DEVELOPMENT APPLICATION ASSESSMENT REPORT

Application Number:	DA2024/1718
----------------------------	-------------

Responsible Officer:	Julie Edwards
Land to be developed (Address):	Lot 1 SP 1173, 1 / 153 Balgowlah Road BALGOWLAH NSW 2093
Proposed Development:	Alterations and additions to a residential flat building
Zoning:	Manly LEP2013 - Land zoned R1 General Residential
Development Permissible:	Yes
Existing Use Rights:	No
Consent Authority:	Northern Beaches Council
Land and Environment Court Action:	No
Applicant:	Charlotte Camille Vergnolle

The application seeks approval for alterations and additions to a residential flat building. The works includes the removal of the balcony of unit 1 and the construction of a ground floor deck.

Figure 1: Proposed deck with size of conditioned deck overlaid in green.

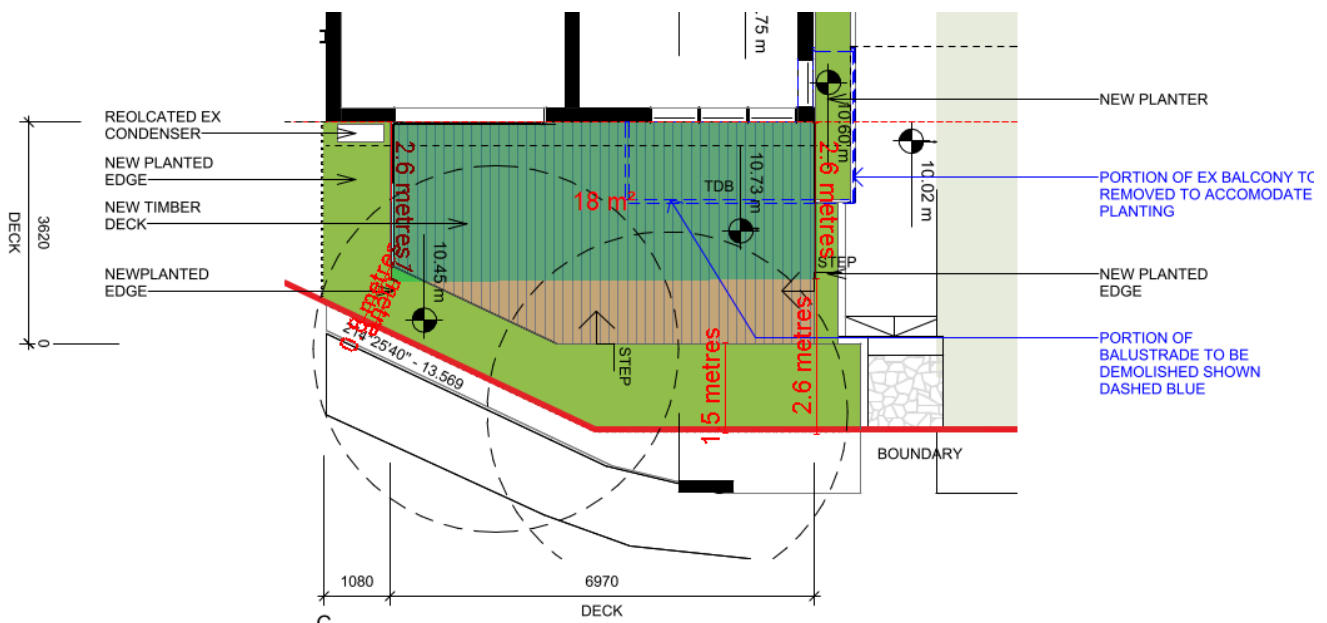
The proposed deck is setback 1-1.5m from the secondary street frontage. Due to the lost of TOS and non-compliance with the secondary setback control, a condition is recommended requiring the deck to be reduced in size by increasing the setback to the secondary frontage. The condition will require the deck to be a maximum length of 7m and a depth of 2.6m. The secondary tree frontage has an irregular shape and result in a setback to the front boundary of 0.8 -2.6m. While a small portion of the deck will be closer to the secondary front boundary the majority of the deck will be appropriately setback from the secondary boundary.

The below merit assessment is based on the recommended condition reducing the size of the deck.

The recommended condition reducing the size of the deck will increase the landscaped area on the site. While the additional landscaped area cannot be included in the LOS calculation due to the dimensions of this area, the landscaped area will provide additional space for landscaping to screen the proposal and storm water absorption for the site.

- The 'new timber deck' is to have a length of 7m and a width of 2.6m.
